# Wizards Workshop

Published by Service Admin Support  
56-037

June 5, 1981  
Issue 11-10

DIAGRAM 28 Microprocessor and Control - Partial

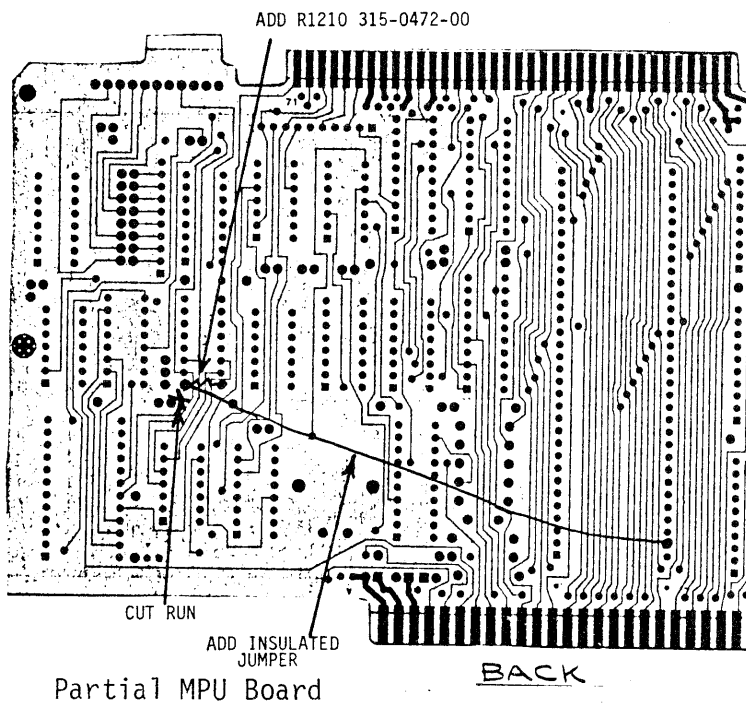
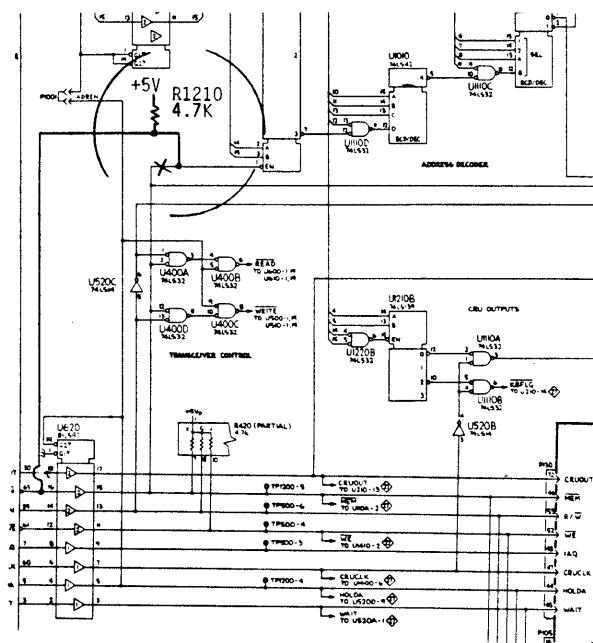
There is a possibility that when single or multiple acquires are requested, the instrument may not stop acquiring. To cure this cut the run going to the enable line of U1210A. Add R1210, a pull-up resistor, P/N 315-0472-00, as per the following drawings.

DIAGRAM 42 CONTROLLED OSCILLATOR, OFFSET MIXER & STROBE DRIVER - Partial

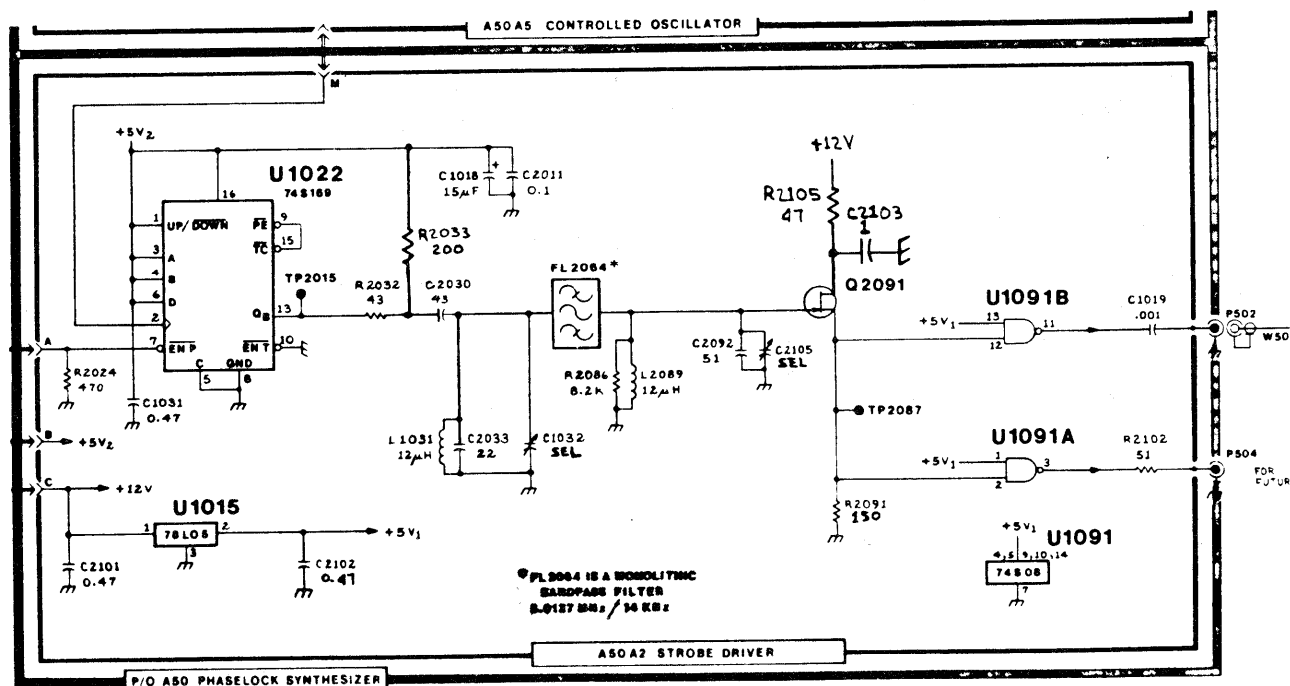
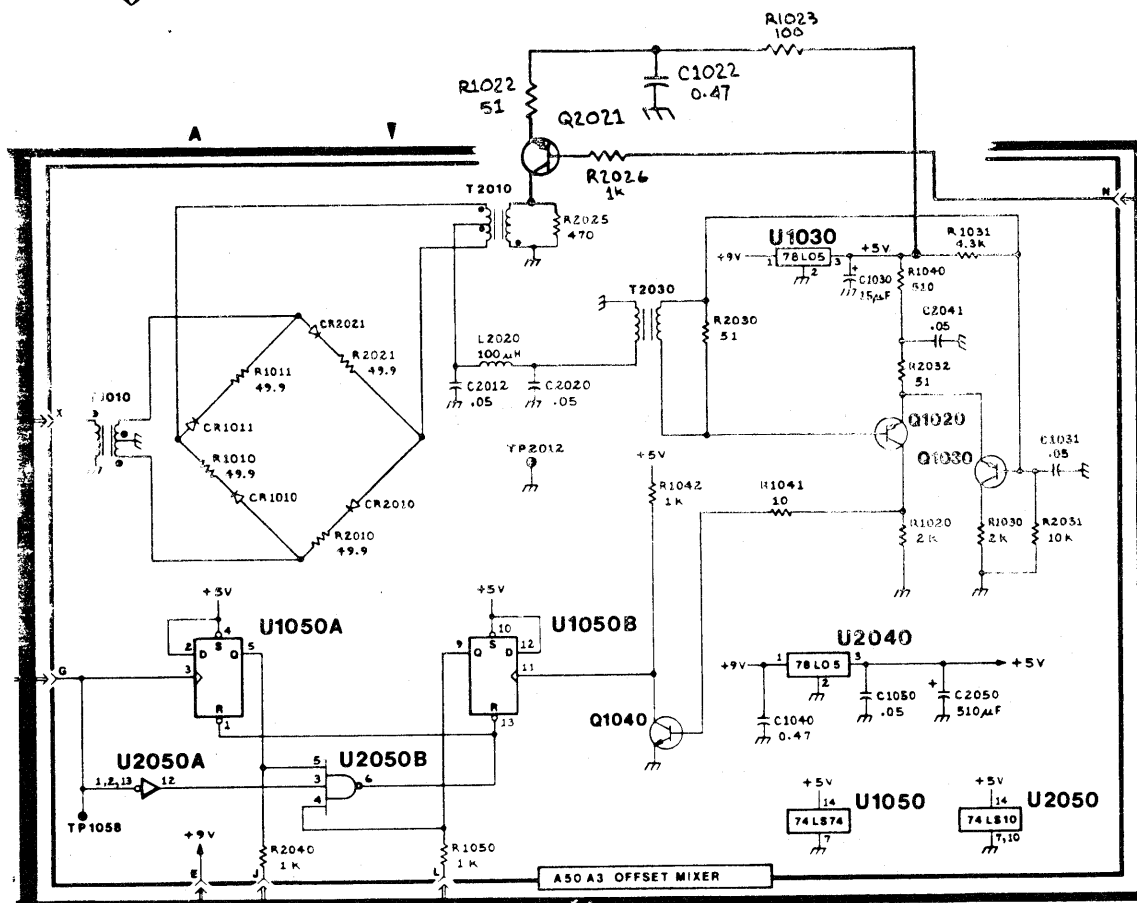
A50A2	670-5520-01	CKT BOARD ASSY:STROBE DRIVER
A50A2C1032	-----	SELECTED
A50-2-2105	-----	SELECTED

The above parts are located on the A50A2 STROBE DRIVER circuit board assembly and shown on the CONTROLLED OSCILLATOR, OFFSET MIXER & STROBE DRIVER diagram 42.

A50A3C1022	283-0203-00	CAP.,FXD, CER DI:0.47UF,20%,50V
A50A3Q2021	151-0434-00	TRANSISTOR:SILICON,PNP
A50A3R1022	315-0510-00	RES.,FXD,CMPSN:510 OHM,5%,0.25W
A50A3R1023	315-0101-00	RES.,FXD,CMPSN:100 OHM,5%,0.25W
A50A3R2026	315-0102-00	RES.,FXD,CMPSN:1K OHM,5%,0.25W

The above parts are located on the A50A3 OFFSET MIXER circuit board assembly and shown on the CONTROLLED OSCILLATOR, OFFSET MIXER & STROBE DRIVER diagram 42.

DIAGRAM 41 ERROR AMPLIFIER AND SYNTHESIZER - Partial

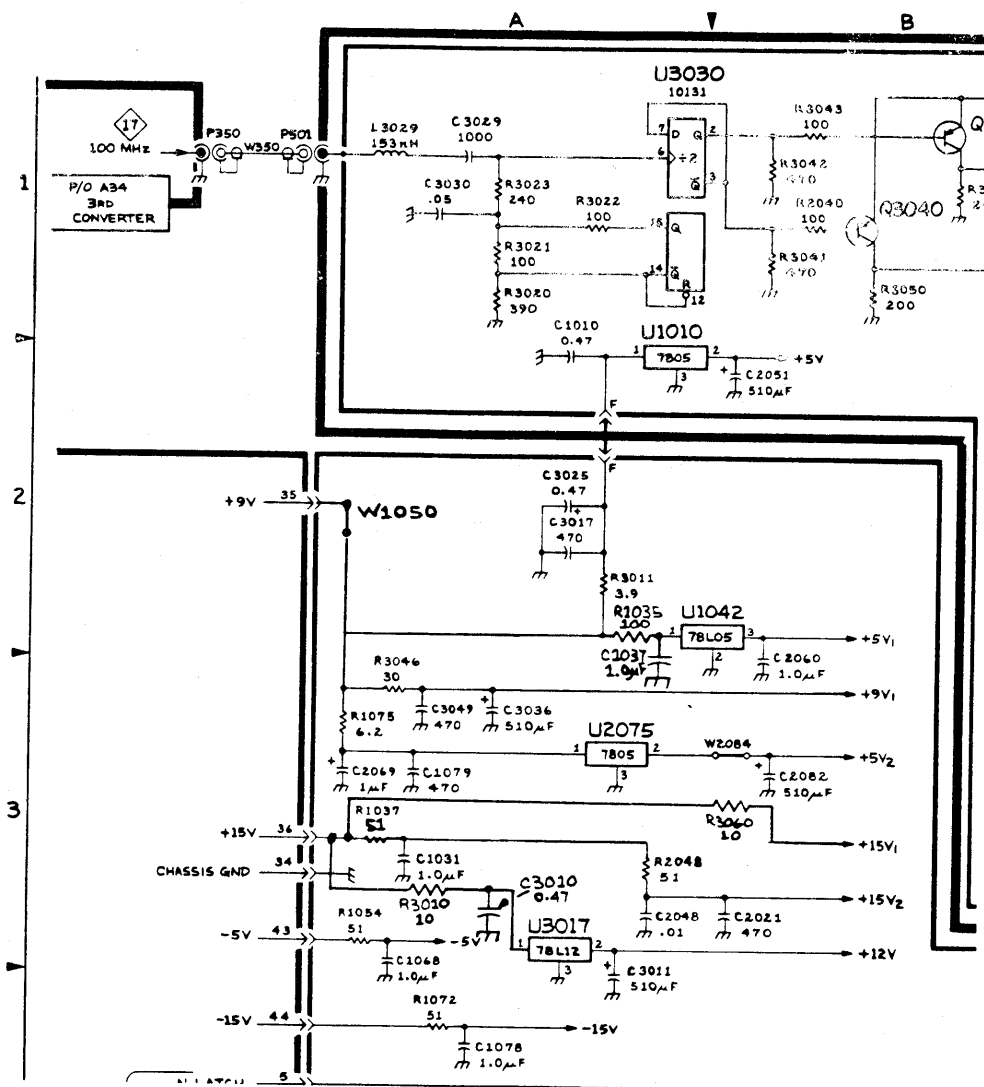
A50A4	670-5521-02	CKT BOARD ASSY:ERROR AMPLIFIER
A50A4R1037	315-0510-00	RES.,FXD,CMPSN:51 OHM,5%,0.25W

A50A4C1055	283-0177-00	CAP.,FXD,CER DI:1UF,+80-20%,25V
A50A4C1067	283-0204-00	CAP.,FXD,CER DI:0.01UF,20%,50V
A50A4C3016	283-0032-00	CAP.,FXD,CER DI:470PF,5%,500V
A50A4L1045	108-0598-00	COIL,RF:200UH
A50A4Q2058	151-0391-00	TRANSISTOR:SILICON,PNP
A50A4R1052	315-0513-00	RES.,FXD,CMPSN:51K OHM,5%,0.25W

A50A4C3010	283-0203-00	CAP.,FXD,CER DI:180PF,5%,500V
A50A4R1035	315-0101-00	RES.,FXD,CMPSN:100 OHM,5%,0.25W
A50A4R3010	315-0100-00	RES.,FXD,CMPSN:10 OHM,5%,0.25W
A50A4R3060	301-0100-00	RES.,FXD,CMPSN:10 OHM,5%,0.50W
A50A4W1050	131-0566-00	BUS CONDUCTOR:DUMMY RES,2.375,22 AWG
